**Beazer East, Inc. and Hatchet Creek Leasing, Inc.**  
**Former Koppers Wood Treating Facility**  
**Montgomery, Alabama**  
**EPA I.D. Number ALD004009403**

**FACT SHEET**

### IV. SUMMARY OF PROPOSED MODIFICATIONS

PROPOSED COVER SYSTEM PLAN

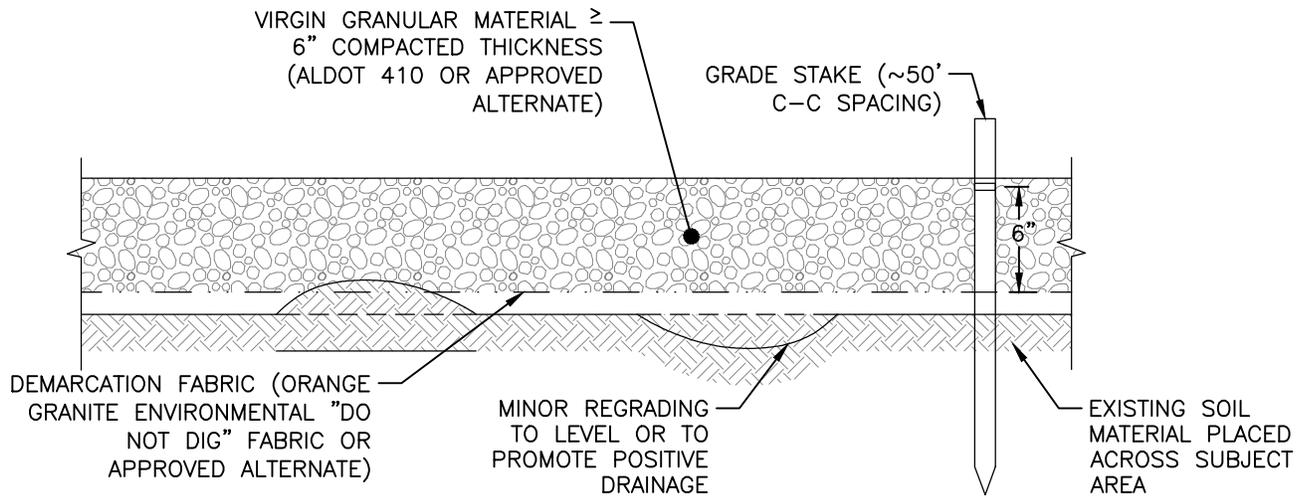
***Additional closure activities to be performed include restoring the approved surface cover by placing orange-colored geotextile demarcation fabric and a minimum of 6-inch aggregate cover in the areas depicted on Figure 3 - Proposed Cover System Plan. Upon the completion of the closure activities, a Final Corrective Measures Implementation (Final CMI) Plan will be submitted to ADEM for approval.***

A visual inspection and survey of the current surface conditions will be completed to aid in the preparation of a grading plan and establishment of limits for placement of a demarcation fabric layer and subsequent placement of a 6-inch-thick gravel cover. Figure 3 presents an aerial site image (2024) with the approximate limits of the proposed cover system.

REPLACEMENT WELL M-14R  
 LOCATION MAP

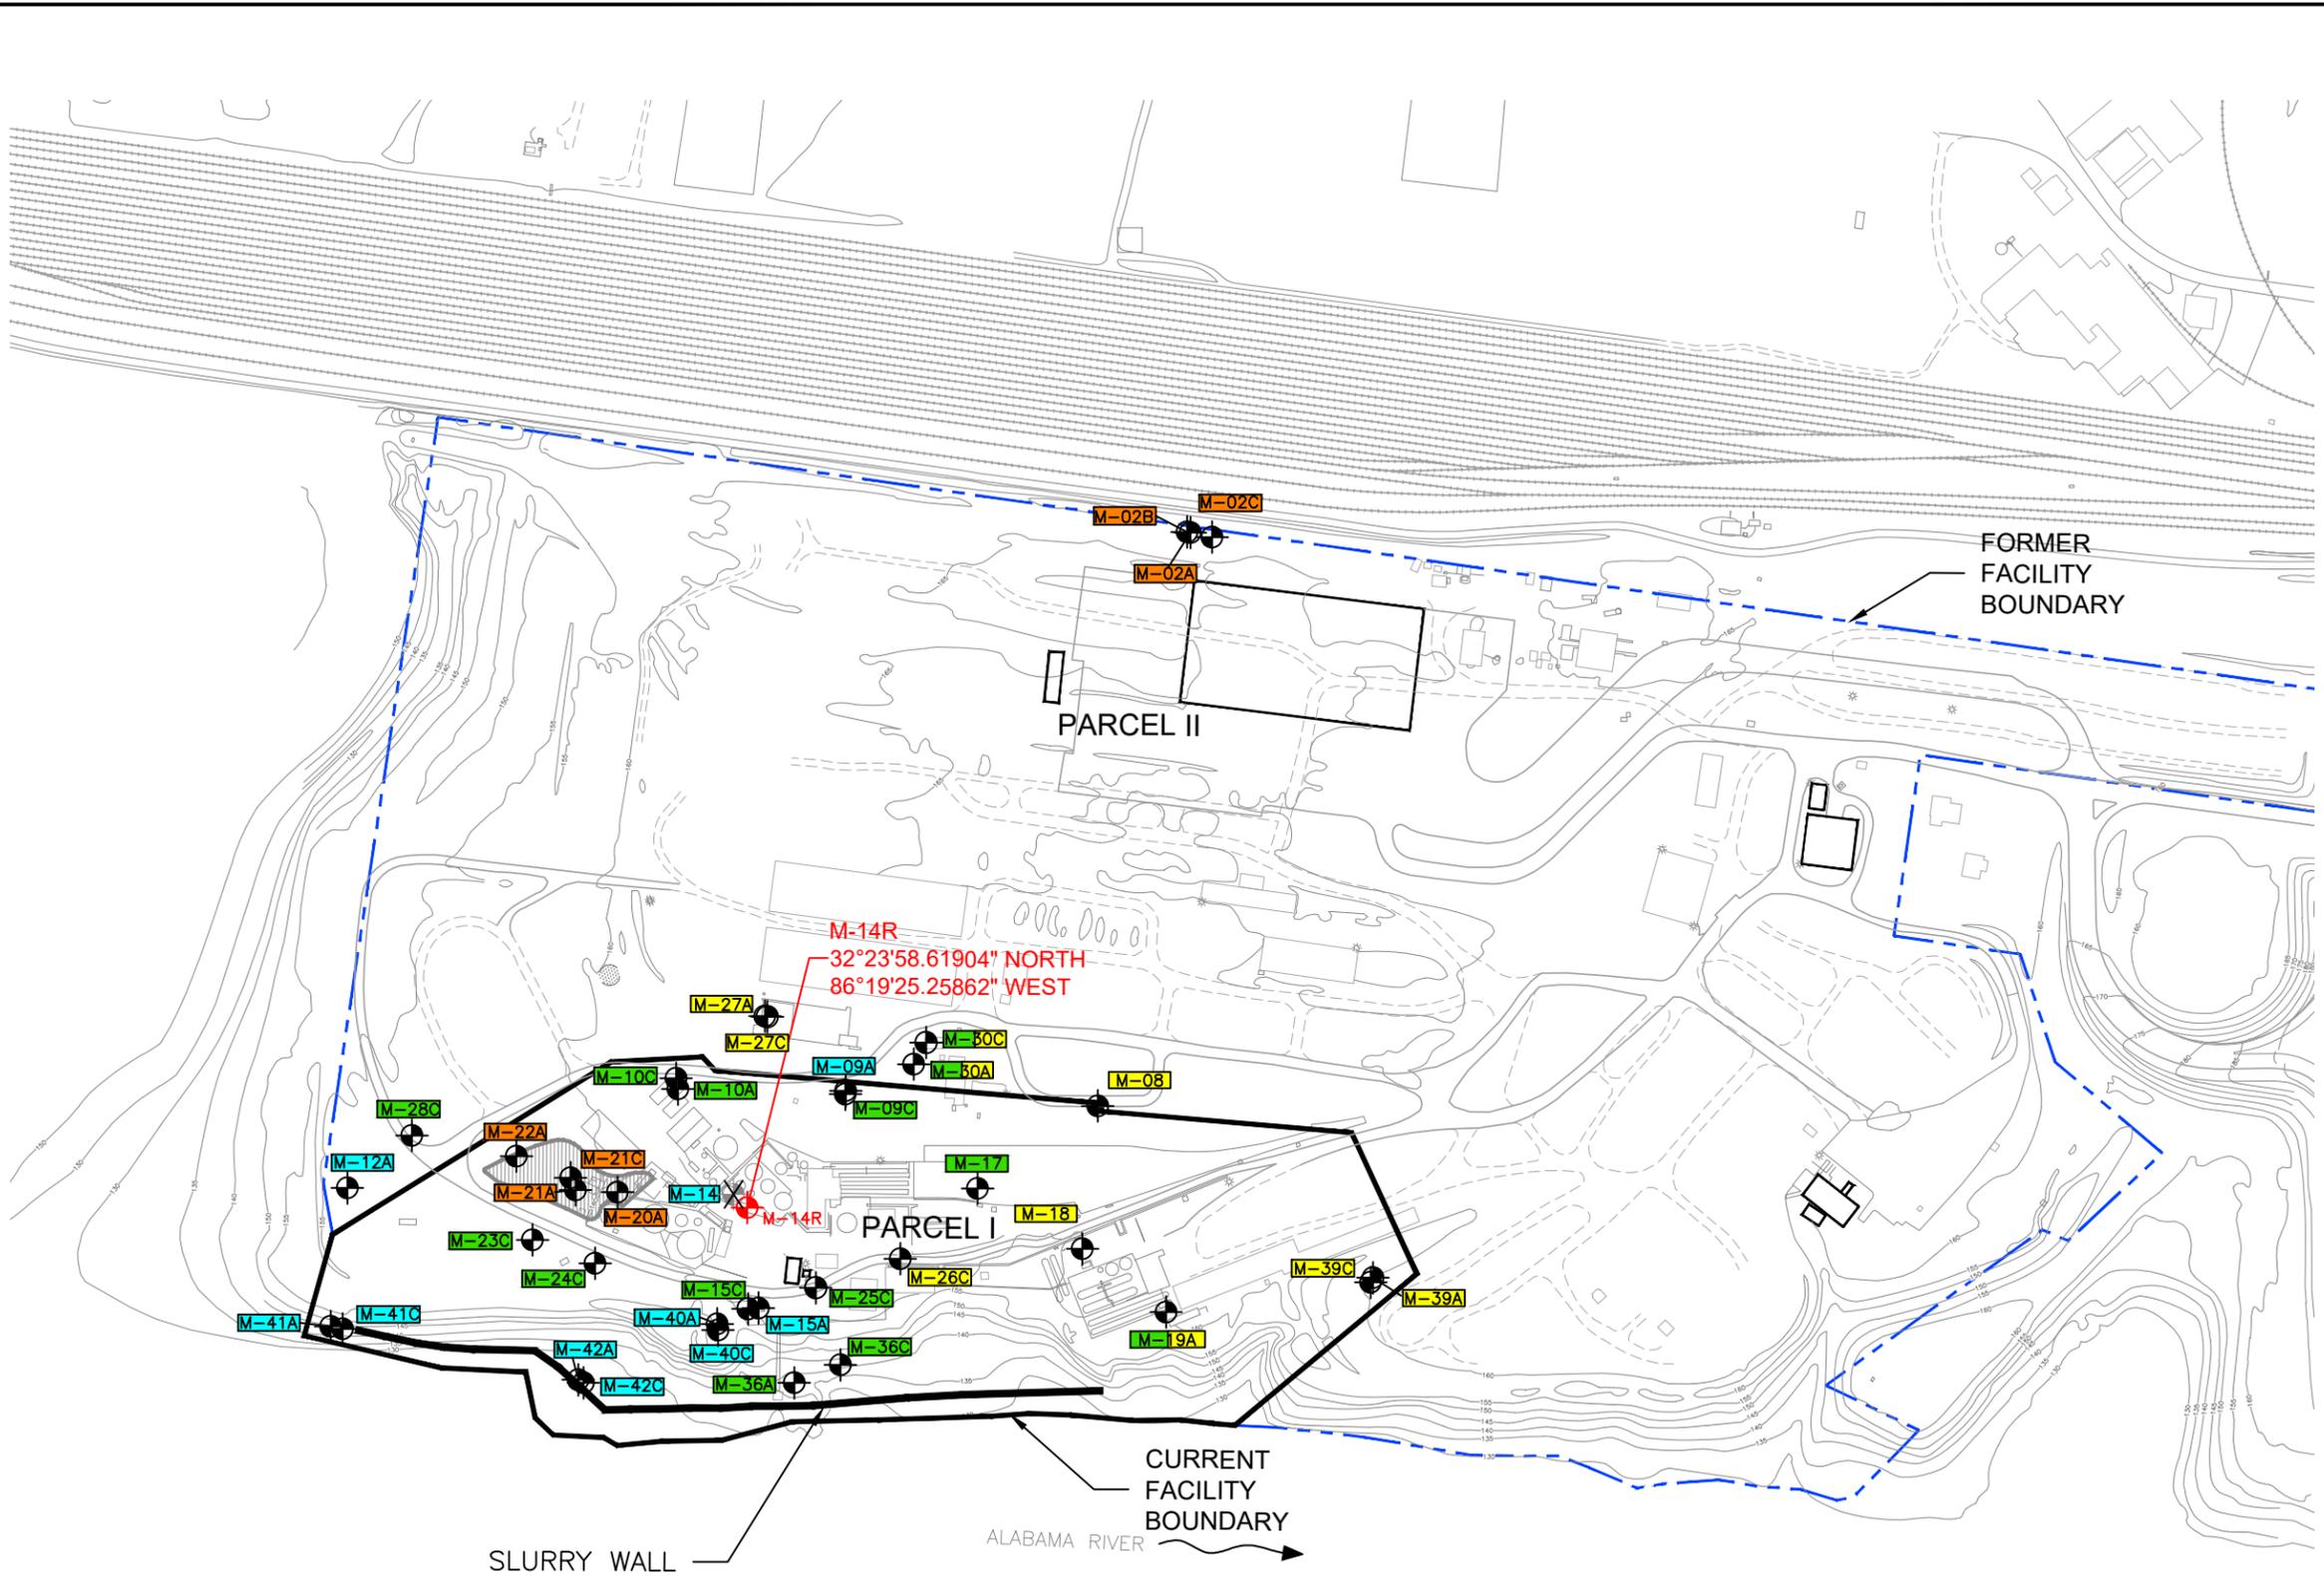
Replacement monitoring well M-14R will be located within 20 feet of the abandoned well (Figure 3), with a goal of installing the replacement well as close to the original well as feasibly possible. Replacement well M-14R will be constructed as shown on Figure 5. Replacement well M-14R will be constructed with 2-inch inside diameter stainless steel riser pipe and a 10-foot long, 0.010-inch slotted stainless steel well screen. The rationale for using stainless steel well materials is to ensure compatibility with the possible presence of dense non-aqueous phase liquids (DNAPL) that may be present in the overburden, as identified on the attached M-14 boring log from June 1985. A coarse sand filter pack will be placed in the annular space from the bottom of the boring to a height of no less than two feet above the top of the stainless steel screen. A bentonite seal having a minimum thickness of two feet will be placed above the filter pack and hydrated. After allowing time for adequate hydration of the bentonite pellets, the remaining annulus will be sealed with the previously specified cement/bentonite grout mixture. The grout will be placed from the bottom of the annular space to within 0.5 feet of the surface using tremie pipe methods.

BEAZER EAST, INC. PITTSBURGH, PENNSYLVANIA	
DRWN: SCC	DATE: 12/08/25
CHKD: DK	DATE: 12/08/25
APPD: JSZ	DATE: 12/08/25
SCALE: AS SHOWN	
LETTER WORK PLAN FORMER KOPPERS INC. FACILITY MONTGOMERY, ALABAMA	
REPLACEMENT WELL M-02CR LOCATION MAP	PROJECT NO: 25062-02 FIGURE 4

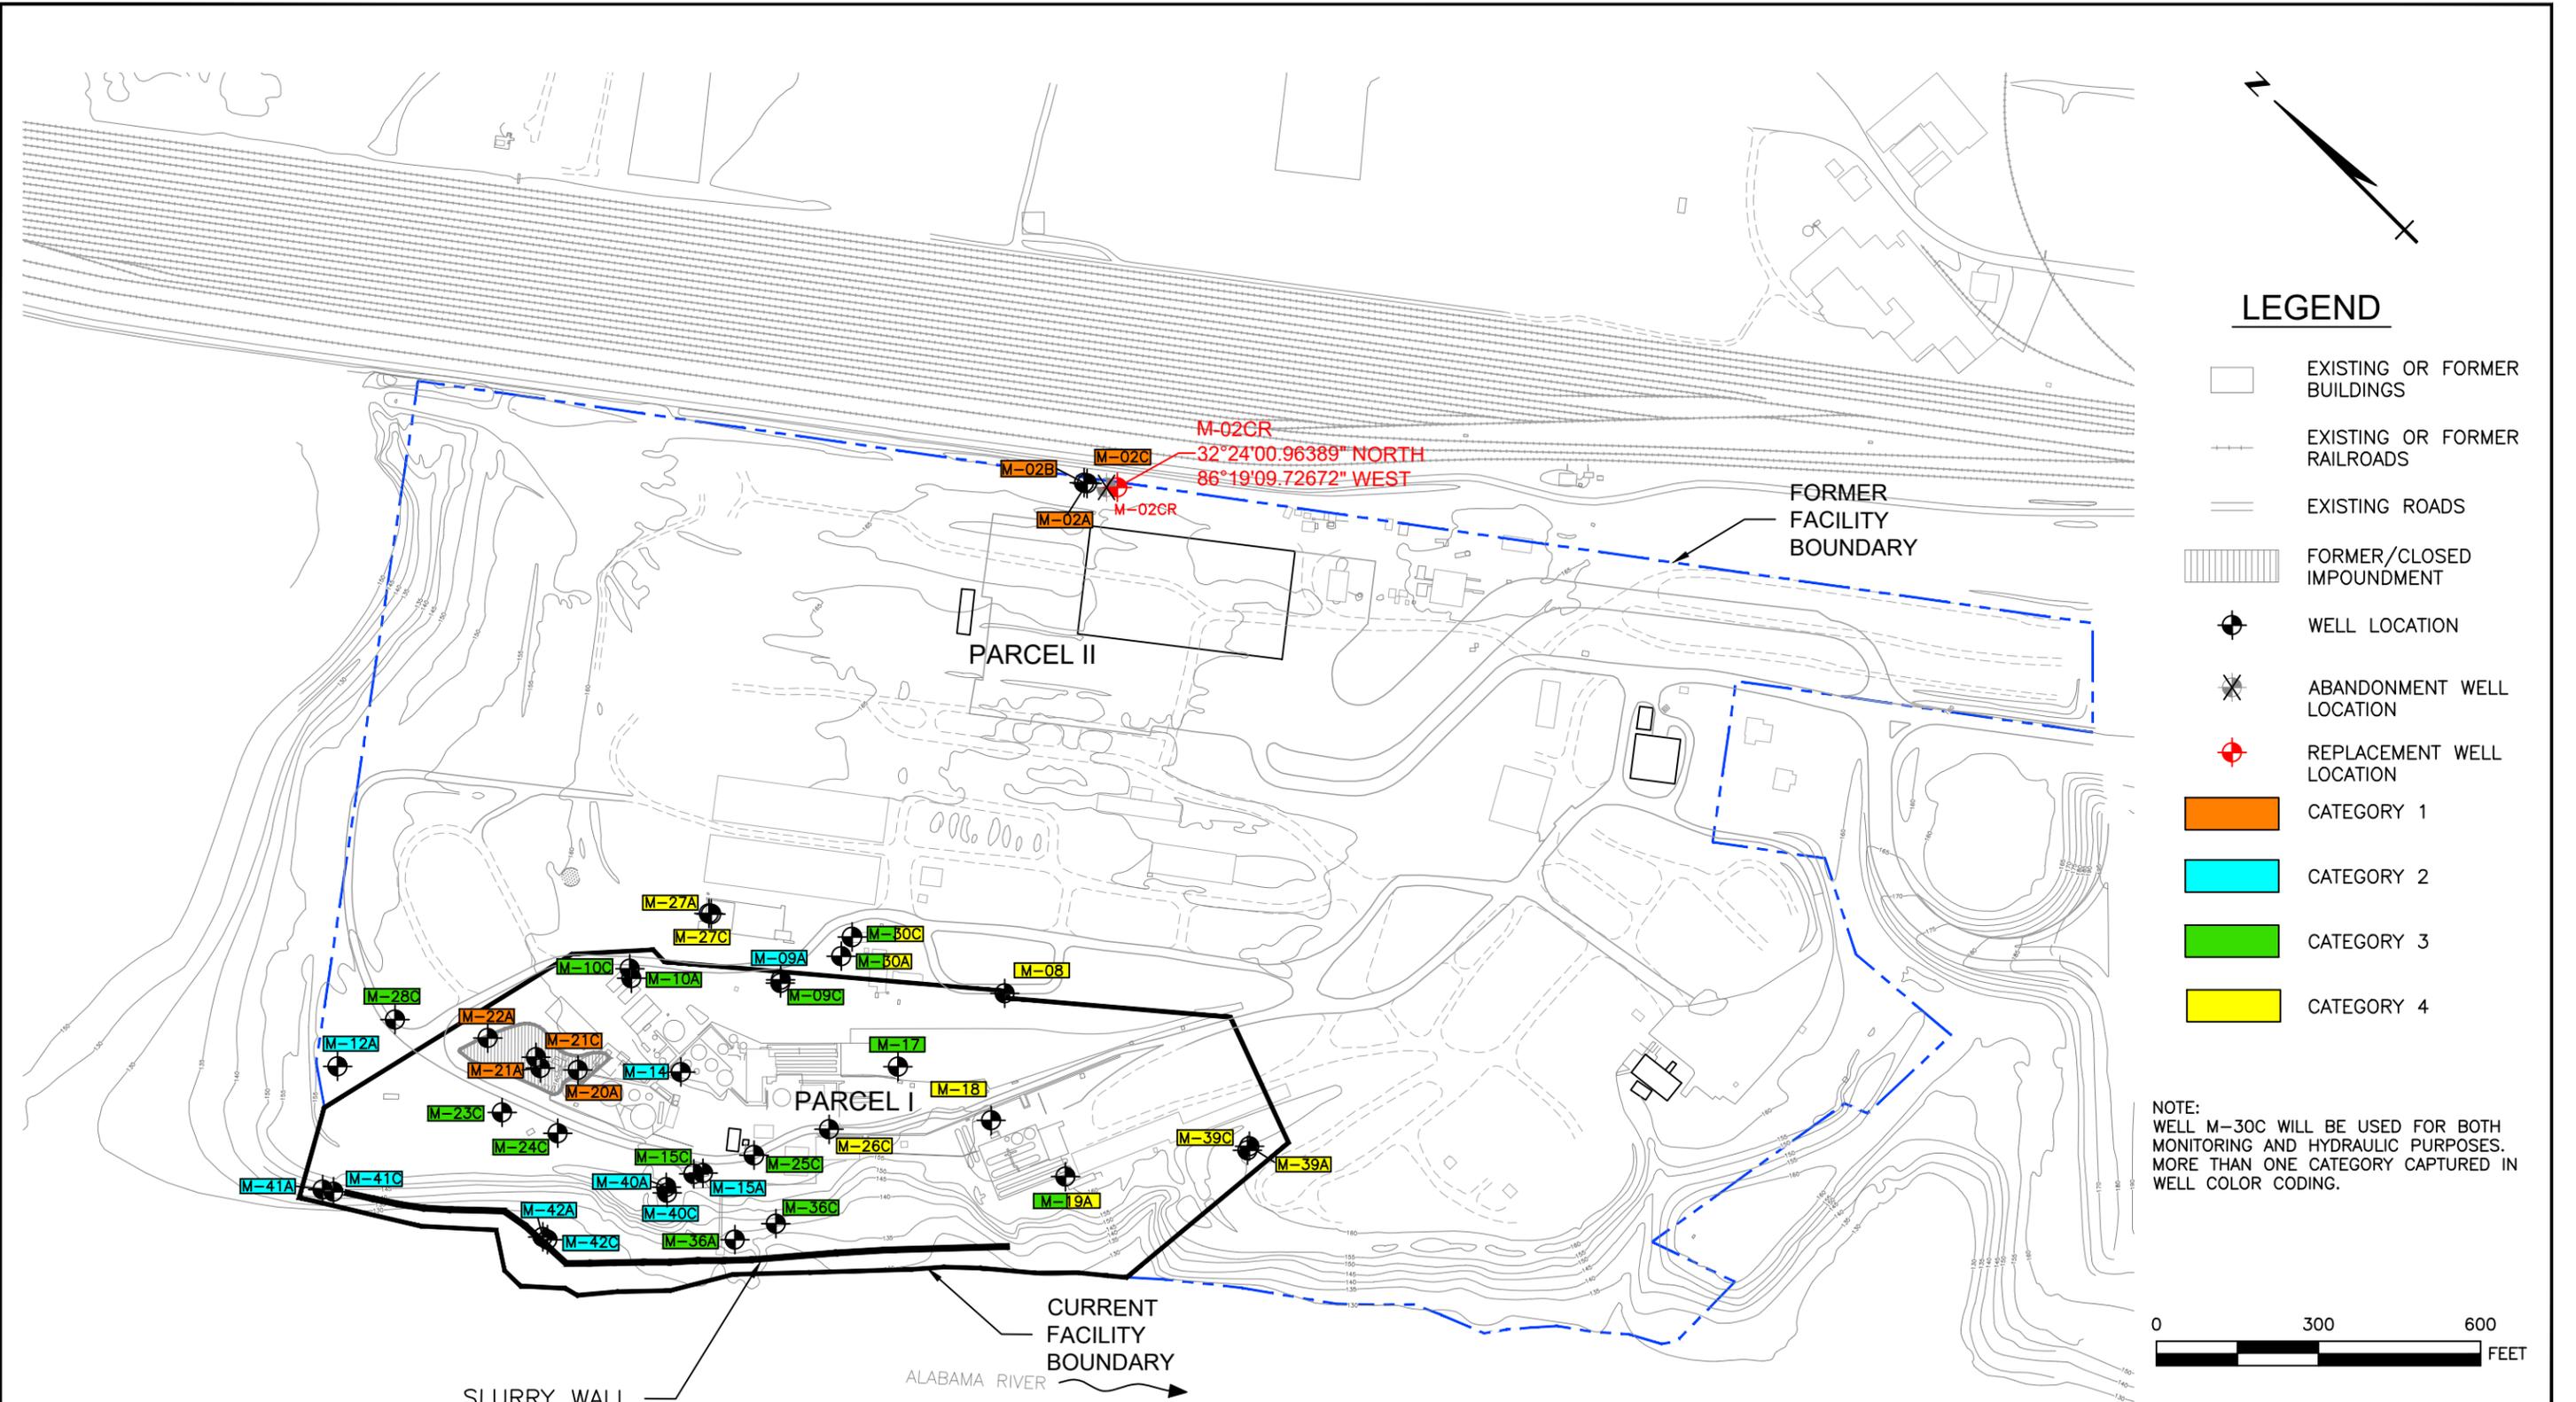
Replacement monitoring well M-02CR will be located within 20 feet of the abandoned well (Figure 4), with a goal of installing the replacement well as close to the original well as feasibly possible. Replacement well M-02CR will be constructed as shown on Figure 6. Replacement well M-02CR will be constructed with 4-inch diameter PVC riser pipe and a 10-foot long, 0.010-inch slotted PVC well screen similar to the original well. A coarse sand filter pack will be placed in the annular space from the bottom of each boring to a height of no less than two feet above the top of the screen section. A bentonite seal having a minimum thickness of two feet will be placed above the filter pack and hydrated. After allowing time for adequate hydration of the bentonite pellets, the remaining annulus will be sealed with the previously specified cement/bentonite grout mixture. The grout will be placed from the top of the hydrated bentonite seal to within 0.5 feet of the surface using tremie pipe methods.
